R1.1 TOWER WALL TYPOLOGIES

145 BROADWAY

DESIGN REVIEW RESPONSE NOVEMBER 22, 2016

GROUND FLOOR MATERIALS R1.2.1

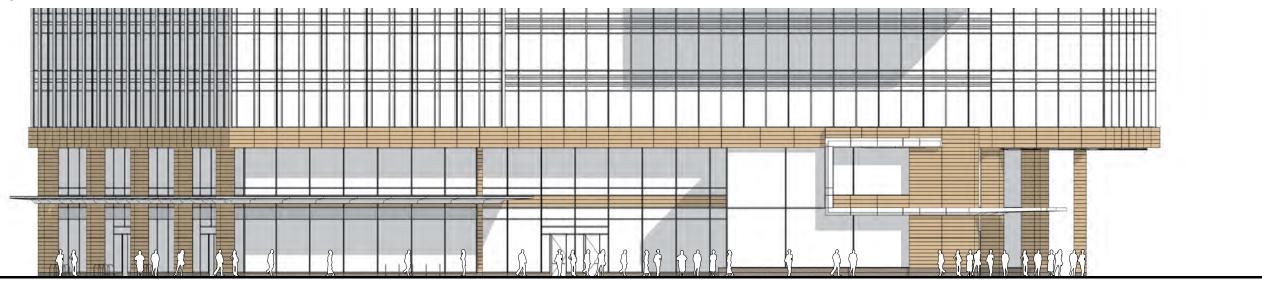
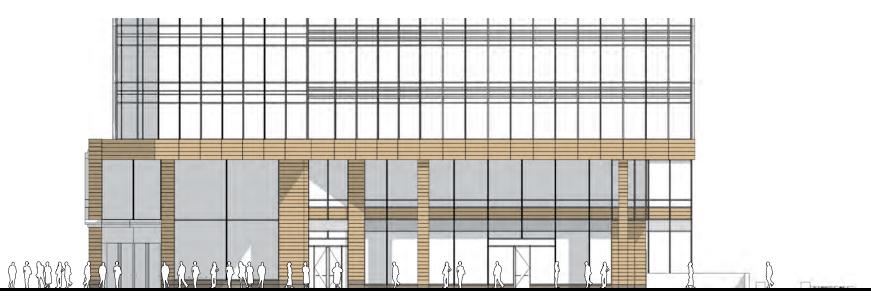
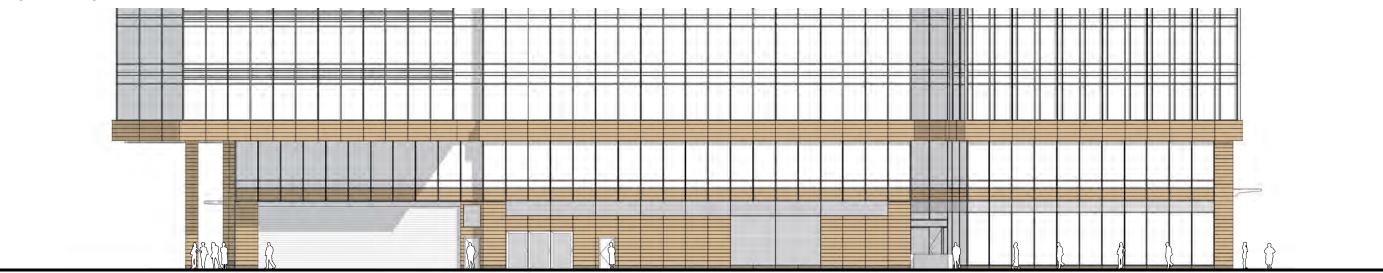
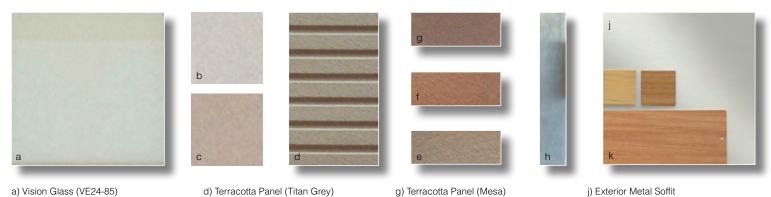
Applicant received questions about the extent of the terracotta on the first and second floor along with comments and questions about the ground floor experience and its relationship to the tower. The design of the material and ground floor experience is further explained in the following exhibits including exhibits about retail and way finding Signage.

The composition of the first and second floor materials are a mixture of terracotta and glass with the intent of providing a pedestrian scale base that is distinct from the tower and provides warmer terra cotta that has a relationship (not replication) to the general masonry composition of the existing buildings in Kendall Square. The Terra cotta is woven together with areas of glass which provide transparency and activation to ensure a lively street front experience. The interplay between glass and terra cotta is consistent with the building's overall connected, joinery-like, composition.

R1.3 WEST FACADE MASSING

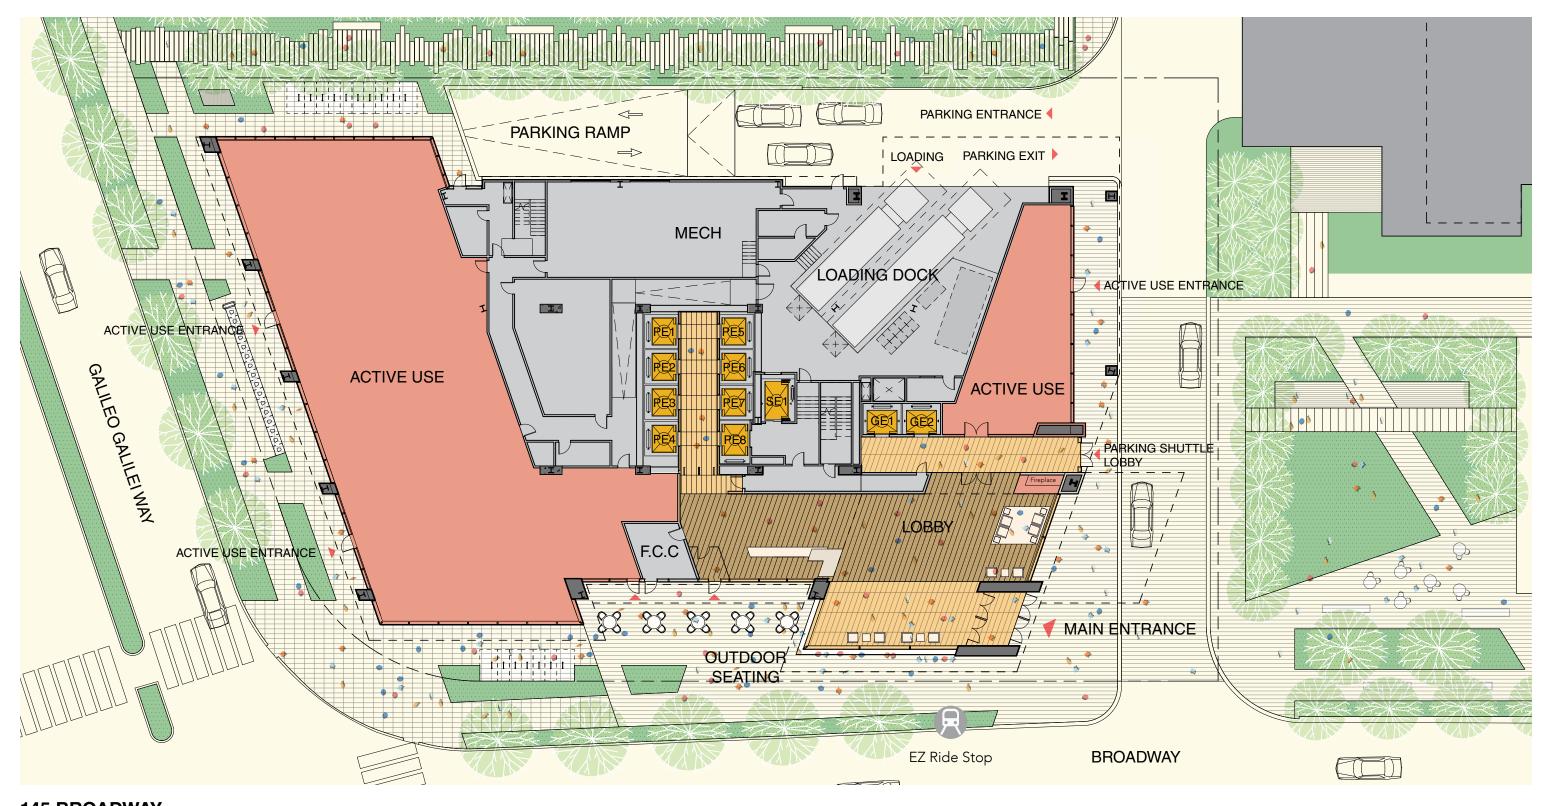
Applicant received comments about potential treatments of the Western facade in relation to its massing and presence as a gateway marker. Applicant believes the design strikes a balance between allowing the simplicity of the massing to mark the corner as a gateway but also providing material selections that are visually interesting from the street as further described above in Section R1.1
